INDIANA DEPARTMENT OF TRANSPORTATION

APPROVED MINUTES

March 15, 2018 Standards Committee Meeting

RE: Minutes from the March 15, 2018 Standards Committee Meeting

Figure 51-9A

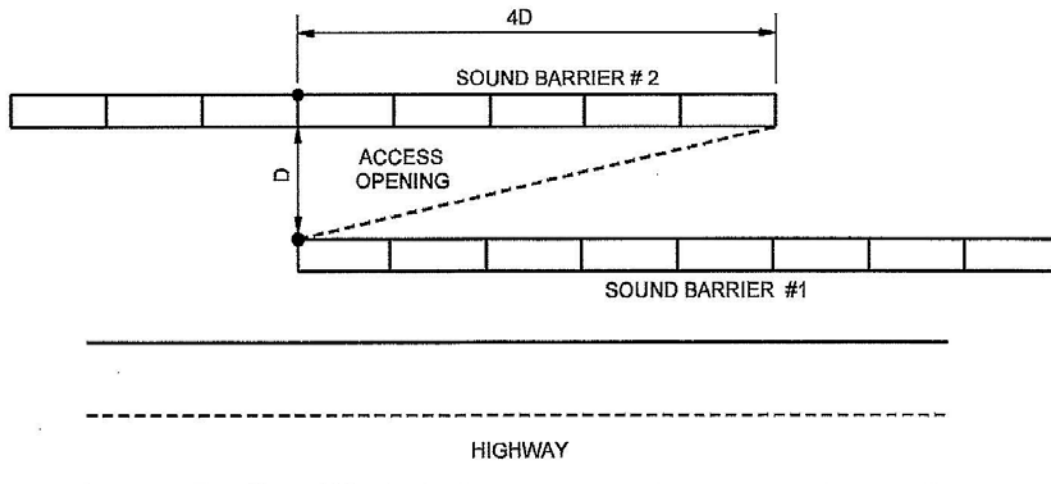
3. Length. To block the roadway noise from the sides, the ends of the barrier should exceed the receiver by four times the distance from the barrier to the receiver; see Figure [51-9A](#), Sound-Barrier Placement, detail (a).

Figure 51-9B

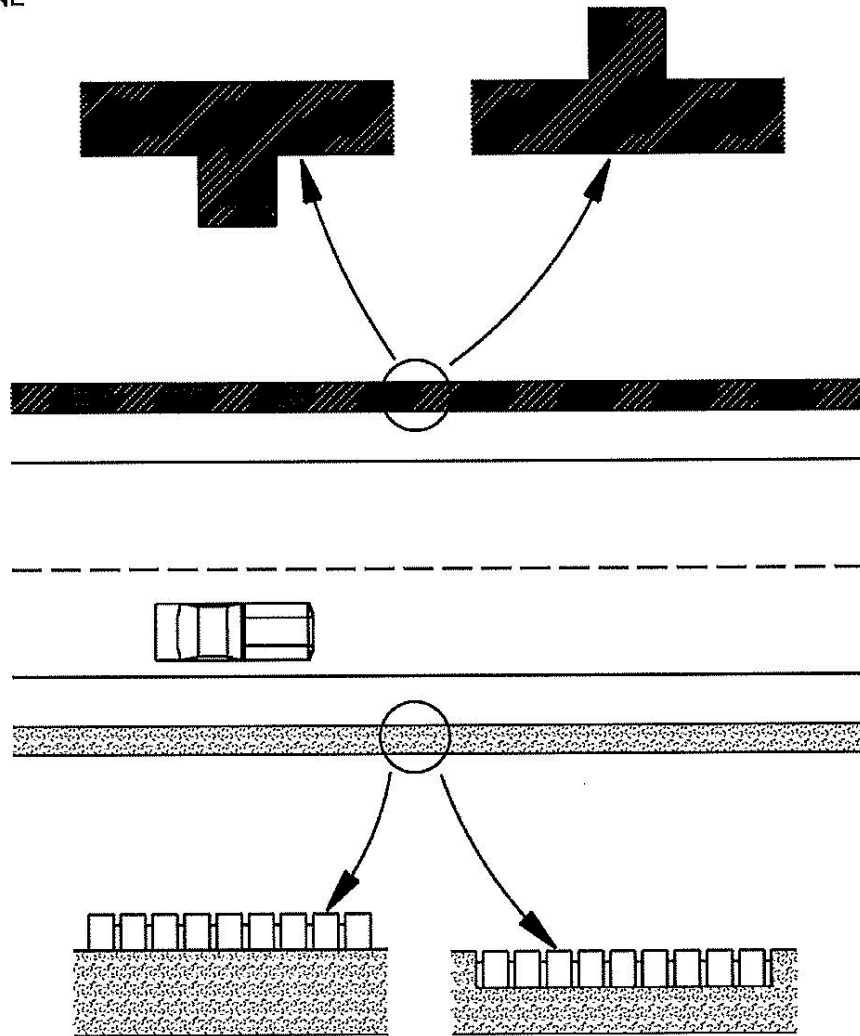
- d. **Protrusion.** A protrusion may become a safety hazard if it ~~are~~ is struck or is dislodged by a vehicle. Figure [51-9B](#), Sound-Barrier Protrusions, illustrates the preferred practice for placing barrier protrusions and decorative facing.

Figure 51-9C

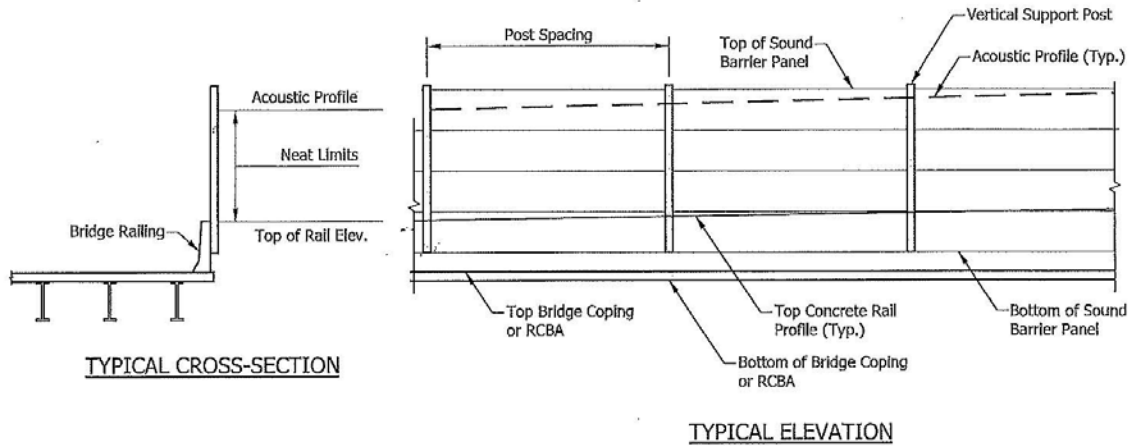
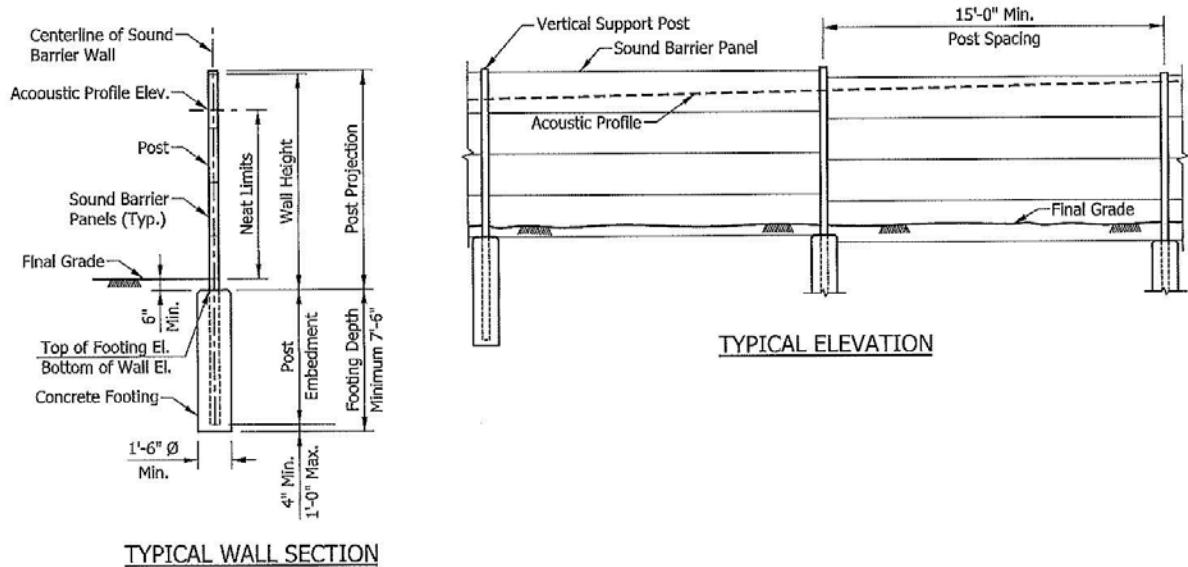
The sound barrier walls attached to the outer face of concrete bridge barrier through vertical supports are termed bridge mounted sound barrier walls, as illustrated by figure 51-9 C. Outside the bridge limits along the roadway, these can be ground mounted on independent support posts and are termed ground mounted sound barrier walls. This illustrated by figure 51-9 D

604-SWCR-02 PERPENDICULAR CURB RAMP TYPICAL PLACEMENT (WITH MARKUPS)

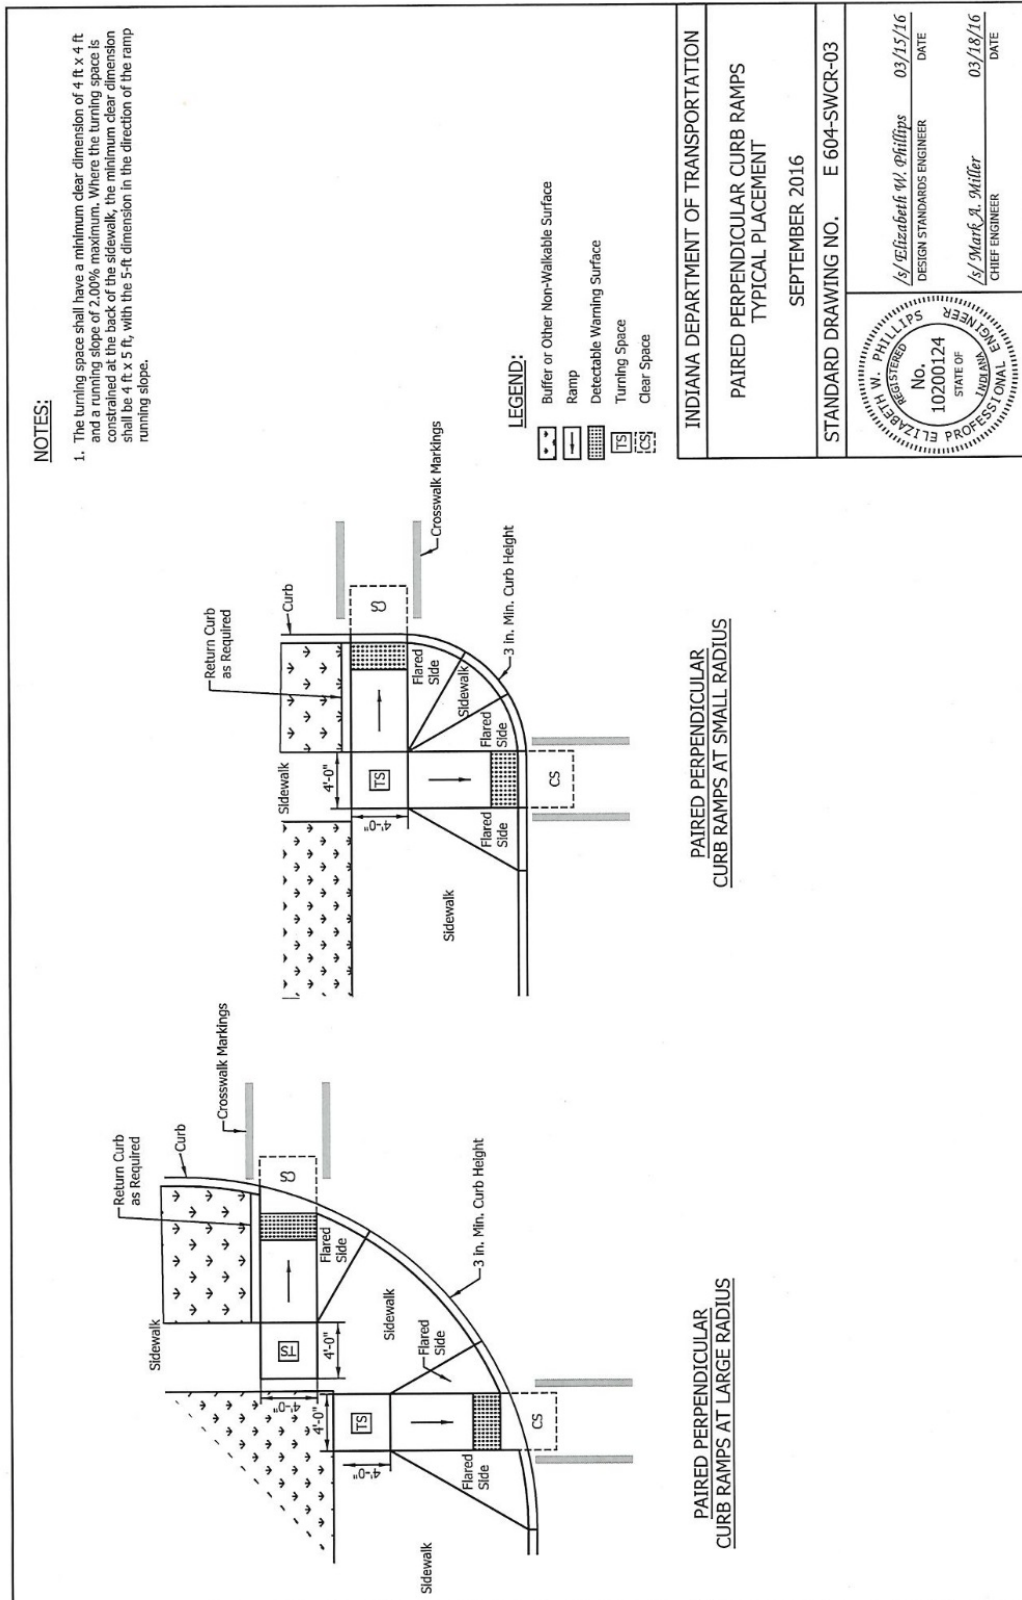
Sheet 2, reference the sidewalk Standard Drawings in Note 1.

604-SWCR-04 PERPENDICULAR CURB RAMP COMPONENT DETAILS (WITH MARKUPS)

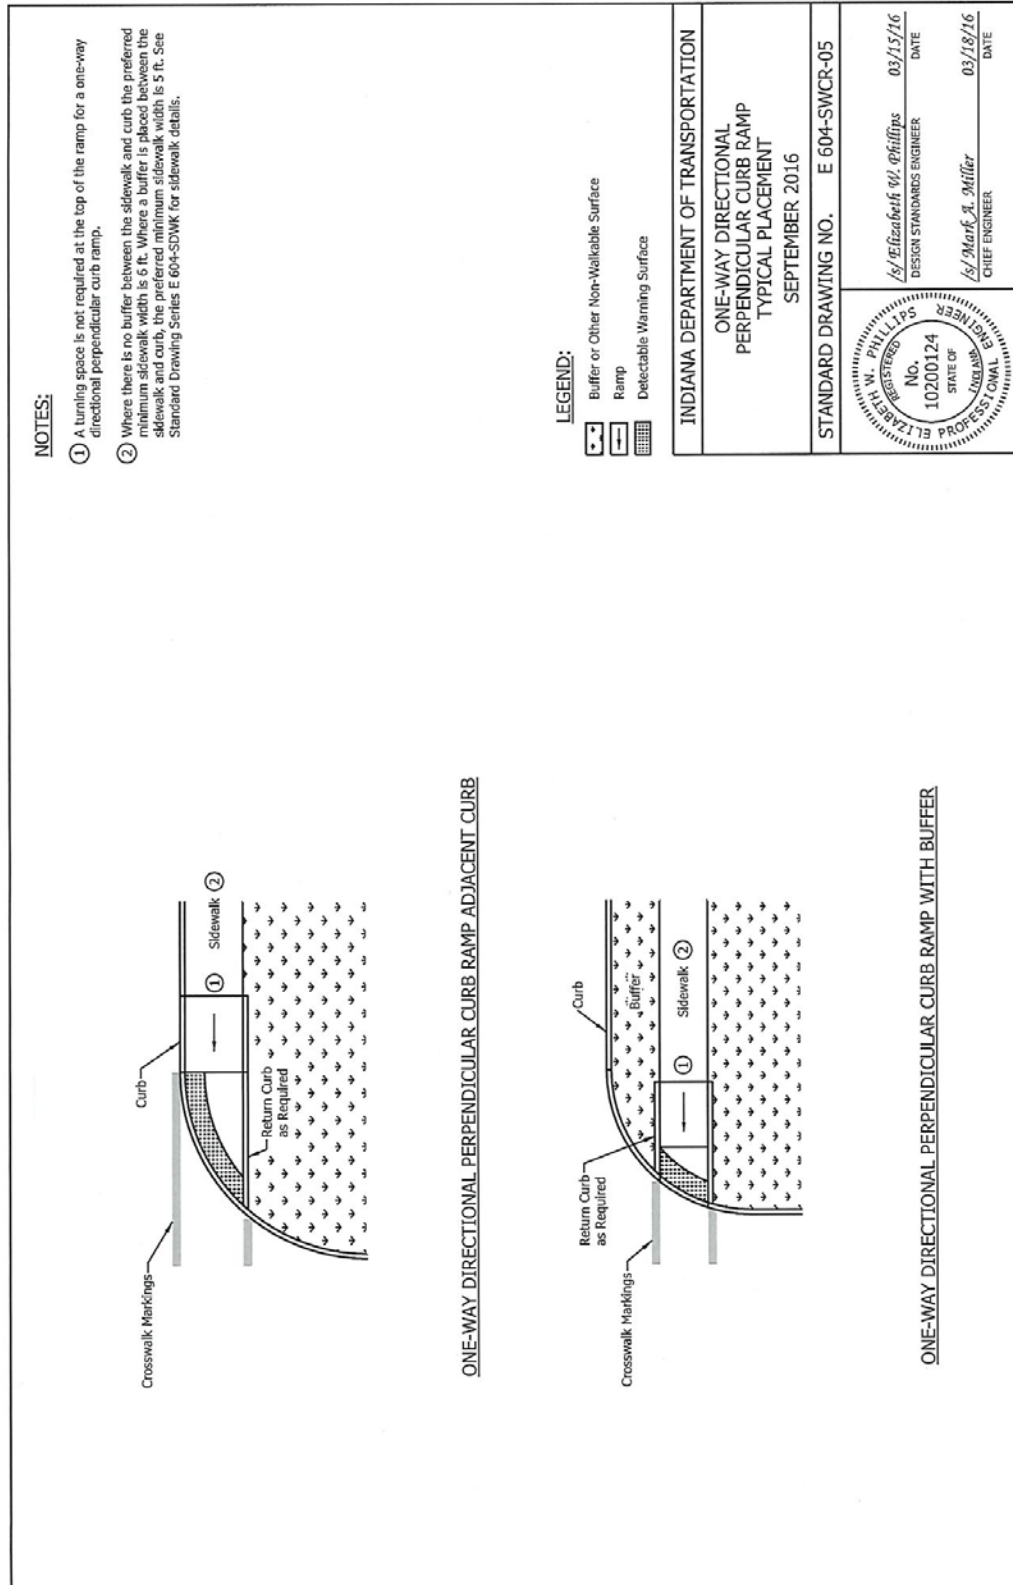
PROPOSED SOLUTION: Revised the Standard Drawing Series 604-SWCR to include the depth of the curb ramp components, sheets 4, 6, 8, 10, and 11.

604-SWCR-13 DETECTABLE WARNING SURFACE PLACEMENT AND CONFIGURATION
 (WITH MARKUPS)

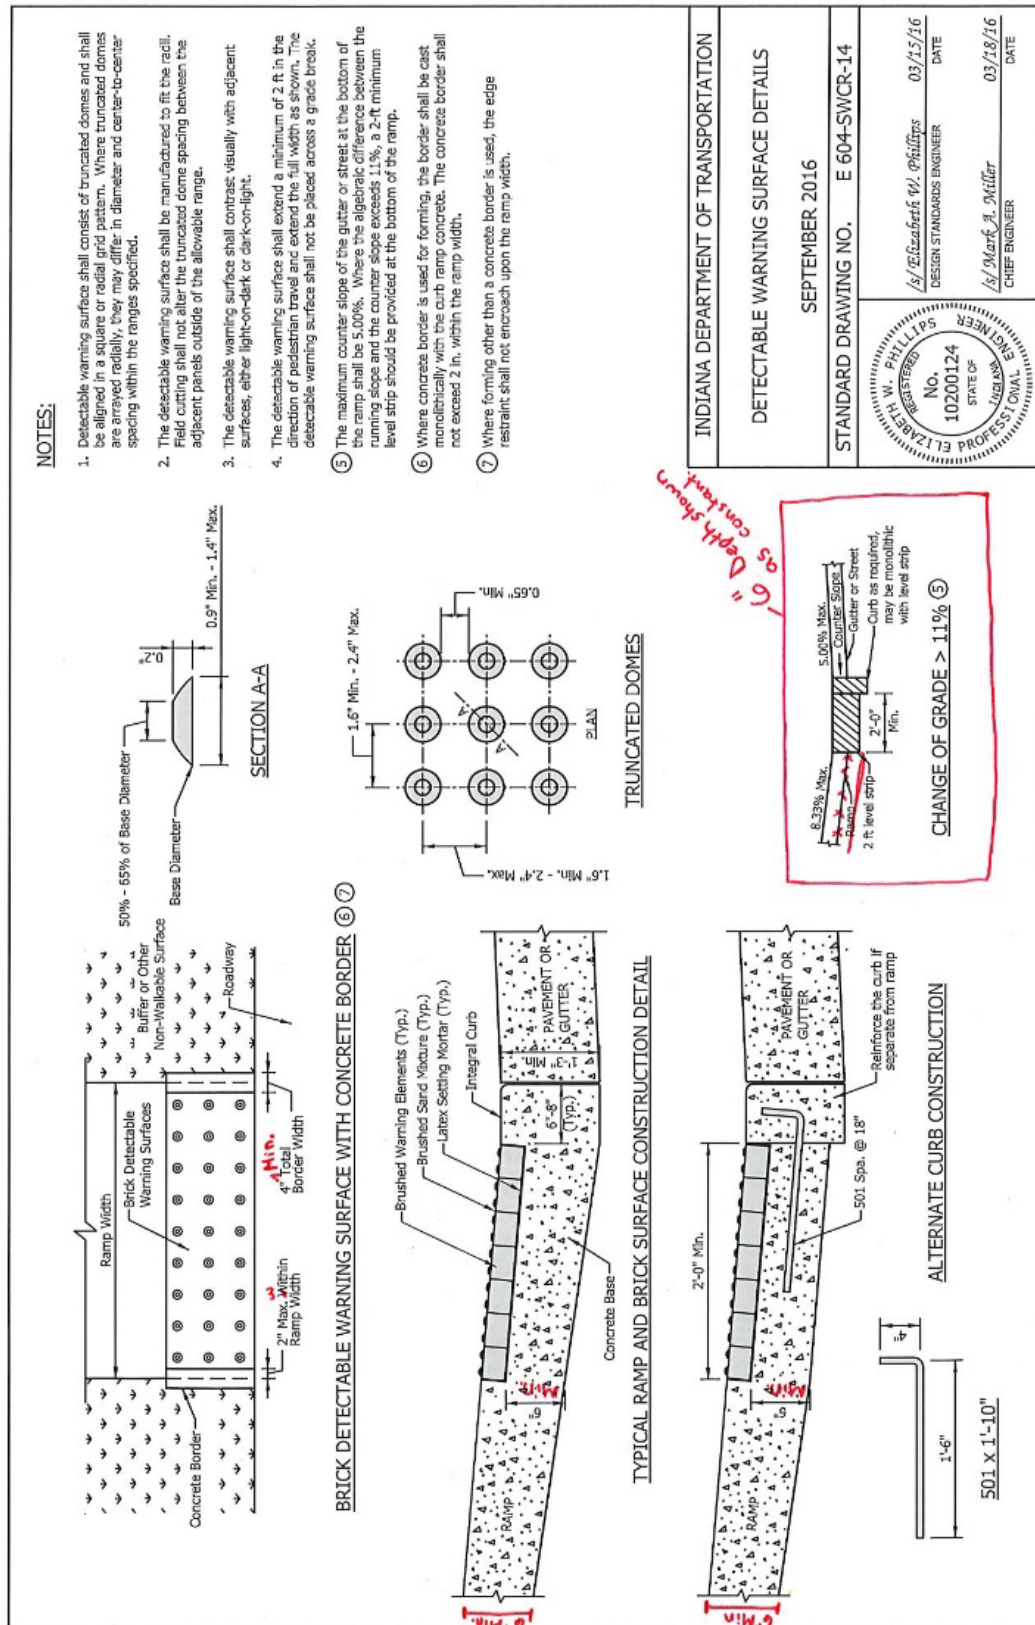
Sheet 13 added a drawing and note for an alternate placement of DWS along a radius.

⑦ Rectangular DWS plates maybe field cut and placed along a radius. Plate ends shall be placed at the back of curb. The distance between the back of curb and the front face of the DWS shall not exceed 6 in. between the ends.

604-SWCR-14 DETECTABLE WARNING SURFACE DETAILS (WITH MARKUPS)

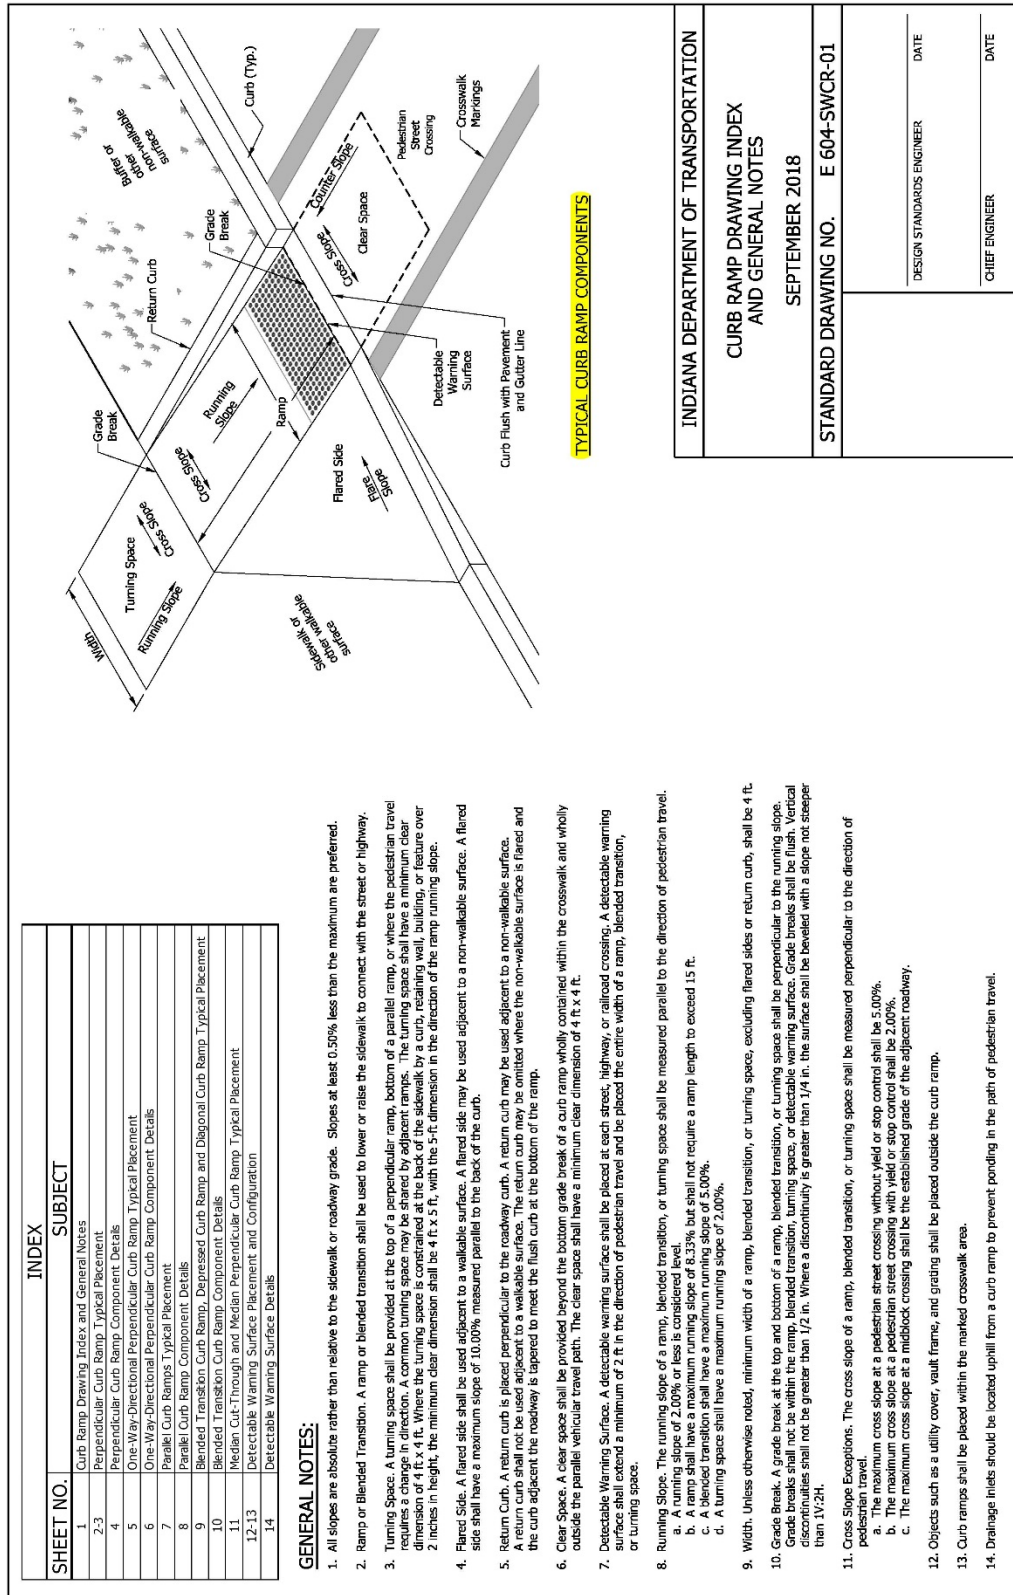
Sheet 14 added a dimension and modified some details to go along with the 6" min. depth for curb ramp components. Minimum was added to the 4" total border width so the contractor did not think the border could only be 4".

Mr. Koch asked about note 2 on sheet 14 regarding the truncated dome spacing. Ms. Phillips explained that it still fits within the specified tolerances. Further discussion ensued concerning spacing, configuration and tolerances. Mr. Koch believes that note 7 on sheet 14 is causing confusion. Mr. Koch suggested combining notes 2 and 7 for clarification. Ms. Phillips said they can revise the notes on sheets 12, 13 and 14 for clarification and consistency.
